15.7 Radioactive Release from Subsystems and Components

The information in this section of the reference ABWR DCD, including all subsections, figures and tables, is incorporated by reference with the following departure and supplements.

STD DEP T1 2.15-1

STD DEP 11.3-1 (Figure 15.7-2)

Figure 15.7-2 Offgas System (See Subsection 11.3)

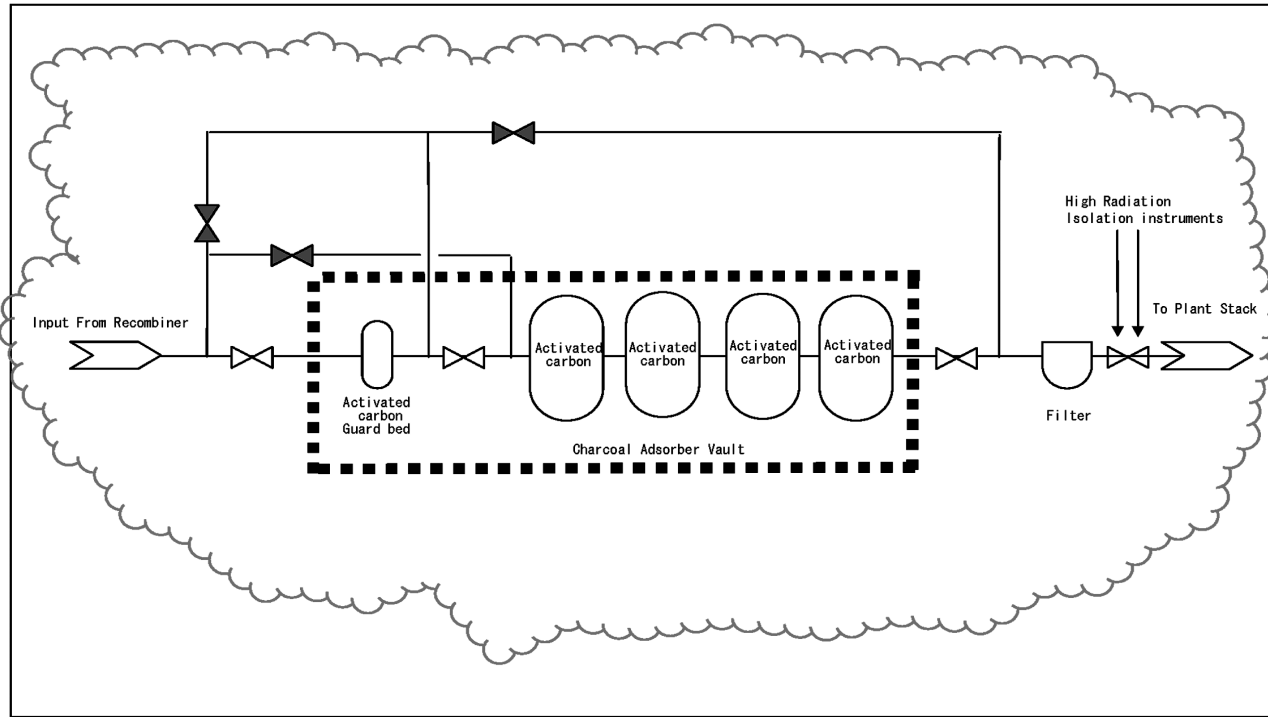
To evaluate the potential radiological consequences of an inadvertent bypass of the charcoal beds, it was assumed that operator error or computer error has led to the bypass of the ~~eight~~four follow-on beds in addition to the failure of the automated air operated downstream isolation valve. It is also assumed that during this period, the plant is running at and continues to run at the maximum permissible offgas rate of 14.8 GBq/s (based upon the assumption of 0.0037 GBq/s/MWt as stipulated in Standard Review Plan 11.3) evaluated to a decay time of 30 minutes from the vessel exit nozzle. Even with the failure of the downstream isolation valve, it is not anticipated or assumed that the isolation instrumentation would fail but would instead

- (1) Flow is through a single 4,721 kg charcoal tank with an evaluated hold up time given by NUREG-0016, equation 1.5.1.6 using K_d 's for Kr and Xe from NUREG-0016.
- (2) ~~An isolation valve prevents flow through the~~ ~~There is no motive force to remove any significant inventory from the eight~~ follow-on charcoal tanks while in bypass and therefore no activity from these tanks is included in the final release calculations.
